# Access Compliance Report

## Public Rights-of-Way

### (Curb Ramps)

Intersection ID: 47914	Main Street: MEARN_RD	Cross Street: ROOK_RD	Location: SE
ADA ID: F200B9D028A9	Ramp Type: PerpDiag	Initial Pass/Fail: Fail	Overall Compliance: No
Codes/Mitigation Info/Possible Solution		Field Measurements/Component Compliance	
Severity Score: 21.25

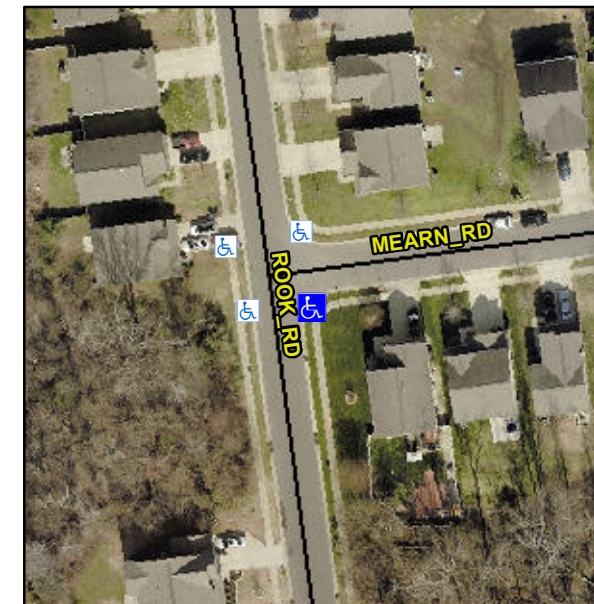
**Not Found, R304.5.1, R304.2.2**

Compliance	Description	Data	Compliance	Description	Data
N/A	Ramp Length (in)	48.0	No	Ramp Slope (%)	9.1
No	Ramp Width (in)	46.0	Yes	Ramp XSlope (%)	1.2
N/A	Flare Type LT	N/A	N/A	Flare Type RT	N/A
N/A	Flare Slope LT (%)	N/A	N/A	Flare Slope RT (%)	N/A
N/A	Flare Traversable LT?	N/A	N/A	Flare Traversable RT?	N/A
N/A	Landing Length (in)	N/A	N/A	DWS Provided?	N/A
N/A	Landing Width (in)	N/A	N/A	DWS Contrast?	N/A
N/A	Landing Slope (%)	N/A	N/A	DWS Length (in)	N/A
N/A	Landing X Slope (%)	N/A	N/A	DWS Full Width?	N/A
N/A	Landing Curb? (Y/N)	N/A	N/A	DWS Offset (in)	N/A
N/A	Shared Landing?	N/A			
N/A	Gutter Ponding?	N/A	N/A	Gutter Slope (%)	N/A
N/A	Gutter Lip Ht (in)	N/A	N/A	Gutter X Slope (%)	N/A
N/A	Painted X Walk1?	No	N/A	Painted X Walk2?	No
	X Walk 1 Direction	To N		X Walk 2 Direction	To W
N/A	X Walk 1 Width (in)	N/A	N/A	X Walk 2 Width (in)	N/A
	X Walk 1 Slope (%)	2.6		X Walk 2 Slope (%)	5.4
	X Walk 1 X Slope (%)	0.9		X Walk 2 X Slope (%)	0.8

**Remove & Replace Curb Ramp With Two New Directional Ramps or Equivalent.**
